PUBLIC BUILDING COMMISSION OF CHICAGO (PBC)
PROFESSIONAL CONSULTANT
CHANGE IN SCOPE OF SERVICE
AMENDMENT NO. 3

Project Name: New Westinghouse High School
Project Location: Kedzie Avenue and West Franklin Blvd.,
Chicago
Owner Agency: Chicago Public Schools
(signature not required - only required for user-directed changes)
Owner Agency Signature, Title & Date
Project Services: Architect of Record (AOR)

CHANGE IN SCOPE OF SERVICE:

ERS-1

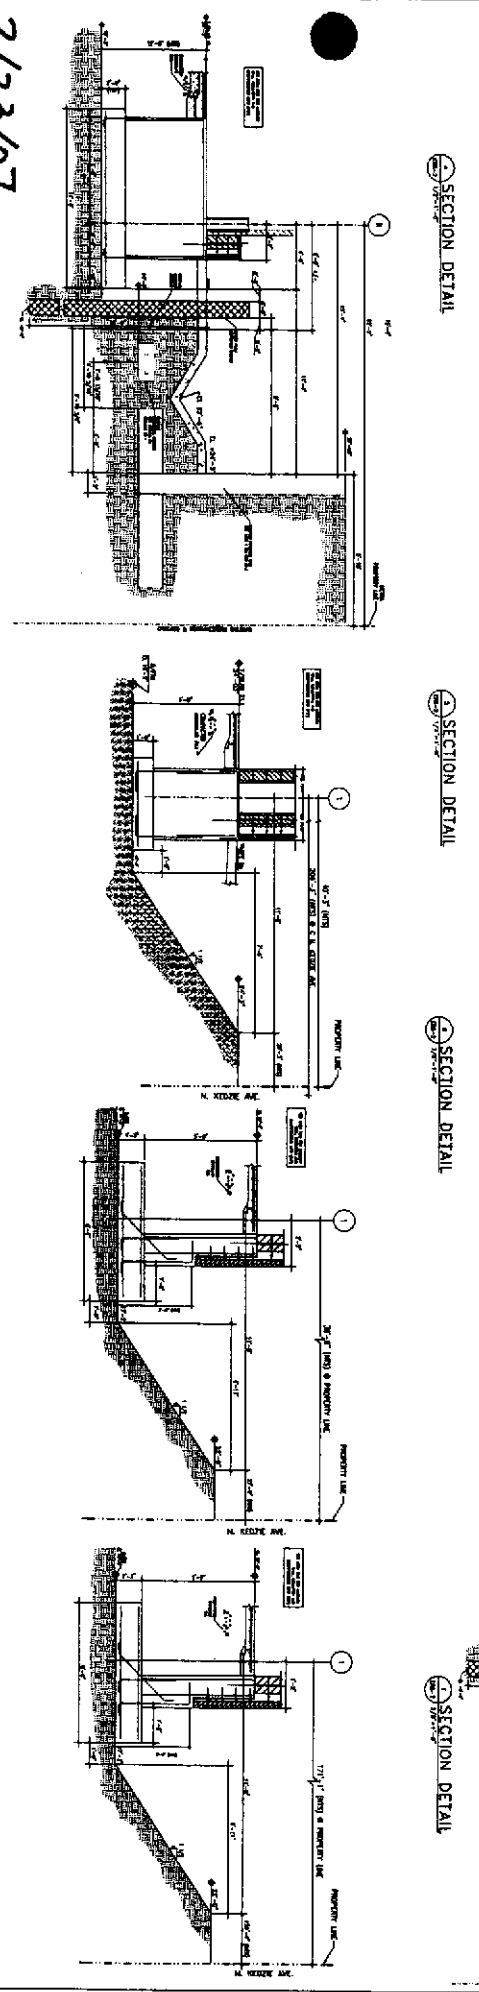
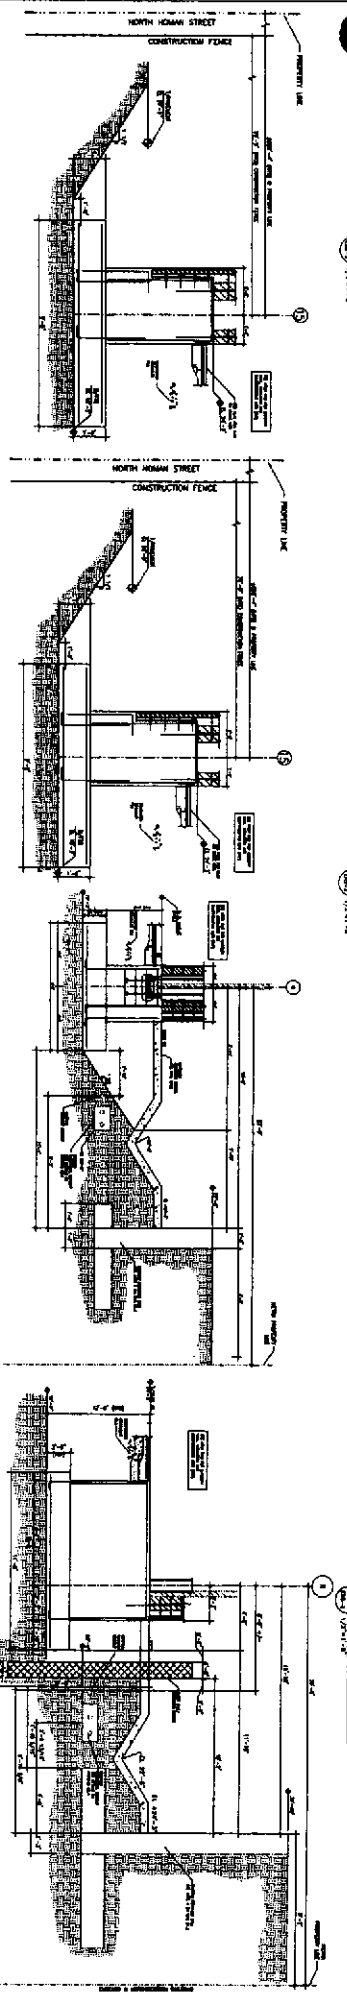
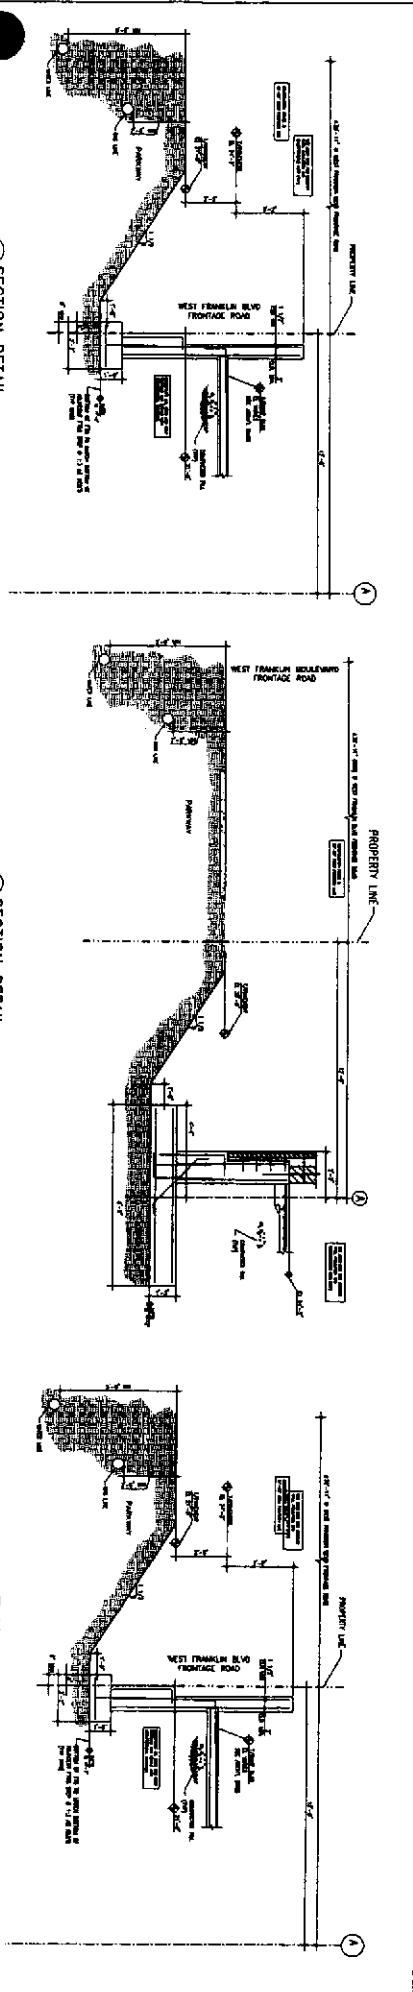
During design of the ERS, OUC required 2 revisions of the drawings due to changes in slope requirements and subsequently, changes in elevations of footings/foundations.

- February 16, 2007 – DeStefano and Partners issued drawings to OUC. Mr. Chawla informed the design team that the slope requirements had changed and therefore our earth retention drawings would need to be modified. Additional changes include elimination of all Phase 3 work and modifications to the existing conditions plan.

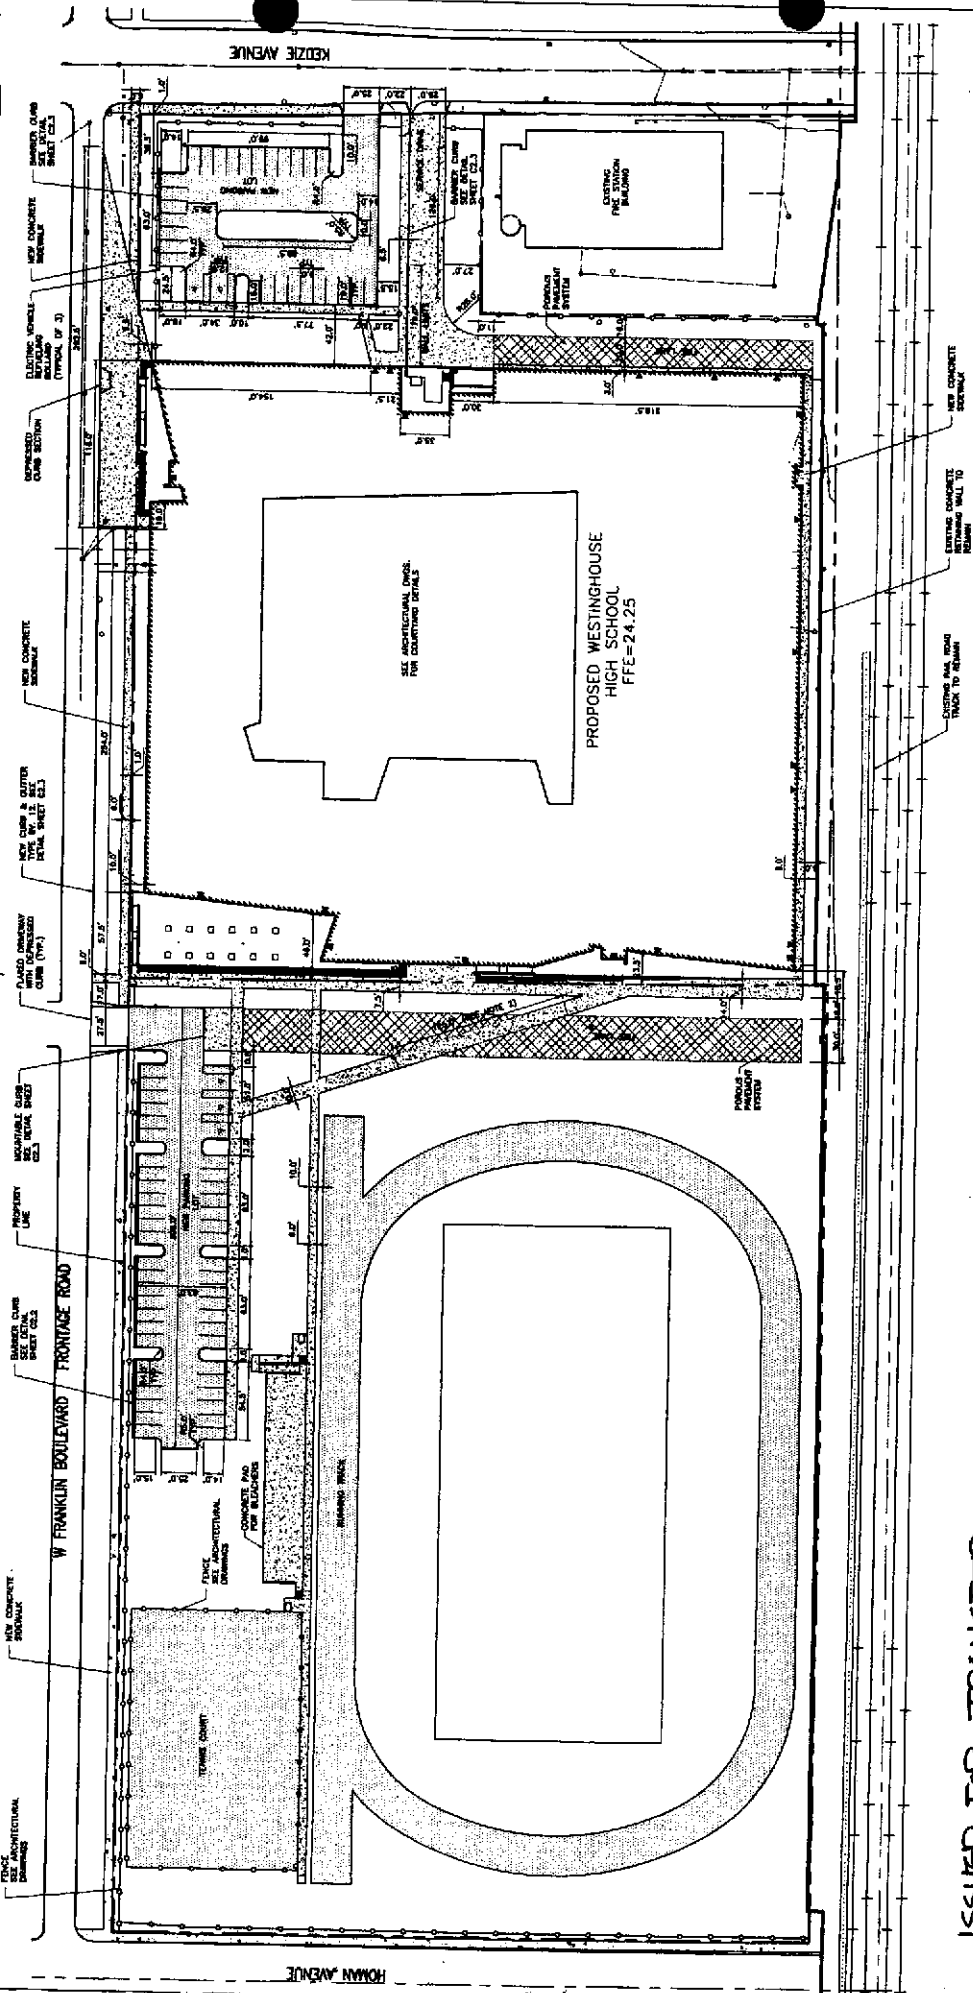
Comments: Show FD current access. Use 5' radii for all driveways.

The applicant is required to revise site & landscape plans / provide requested documents, and resubmit 6 sets of 11x17 copies for Committee review, prior to receipt of Department of Transportation approval stamp. (There is no need to supply the additional supporting documents, as we still have these on file.)

1. Show current Fire Department access;
2. Use 5' radii for all driveways; and
3. Show 6' wide sidewalks.
